## UNITED STATES PATENT AND TRADEMARK OFFICE

<b>Office Action Summary</b>	<b>Application No.</b> 10/596,263	<b>Applicant(s)</b> LEHNERT, FRANK
	<b>Examiner</b> SAMANTHA A. MILLER	<b>Art Unit</b> 3749

**DETAILED ACTION**

**FIG. A Examiner provided figure 9 from McCabe**

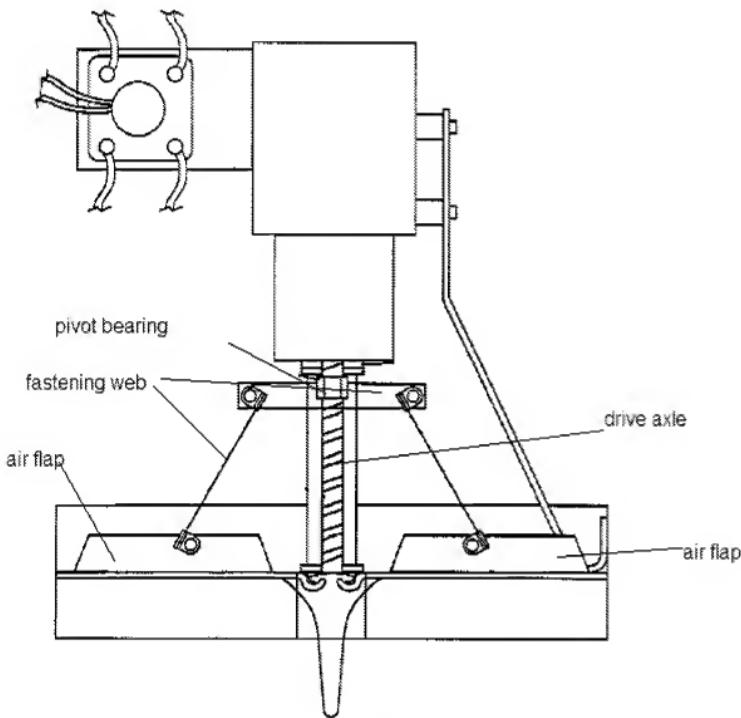
Claims 1-16 are rejected under 35 U.S.C. 102(b) as being anticipated by McCabe (2001/0055947).

1. A fastening web (See Examiner Figure A below) with a pivot bearing (66) (See Examiner Figure A below) for the drive axle (38) (See Examiner Figure A below) of the

air flap(s) (See Examiner Figure A below) and means (the motor, para.0068) (See Examiner Figure A below) for transmitting force and/or torque to the drive axle (para.0068) (See Examiner Figure A below) connected to the air flap(s) (See Examiner Figure A below) are arranged in the ventilating pipe (Fig.8), on a longitudinally extending plane of symmetry, wherein the same fastening web (See Examiner Figure A below) fitted with various air flaps (See Examiner Figure A below) can be used for cross-sectionally differently dimensioned ventilating pipes (Fig.1 and Fig.8).

2. The fastening web extends at an angle of preferably 15 to 90° with respect to the longitudinal axis or the pipe wall of the ventilating pipe (See Examiner Figure A, web's are at 45°).

3. The fastening web is fastened so as to be detachable at one end and so as to be pivotable in the plane of symmetry on the pipe wall (See Examiner Figure A, the webs are attached towards the middle of the flaps).

6. The actuator (the motor, para.0068) of the drive axle(s) (38) is integrated at least partially into the fastening web (See Examiner Figure A), preferably a program-controlled electric motor.

7. The actuator (the motor, para.0068) acts on the drive axle(s) (38) by way of a reducing gear (50) (para.0065).
8. The control electronics (62, 38) are installed at least partially in the fastening web (See Examiner Figure A).

9. The fastening web (See Examiner Figure A) is streamlined, preferably round or prismatic with rounded edges.
10. A fastening point is provided, in each case, on the drive axle (38) on either side of the fastening web (See Examiner Figure A) for the air flap(s) (See Examiner Figure A).
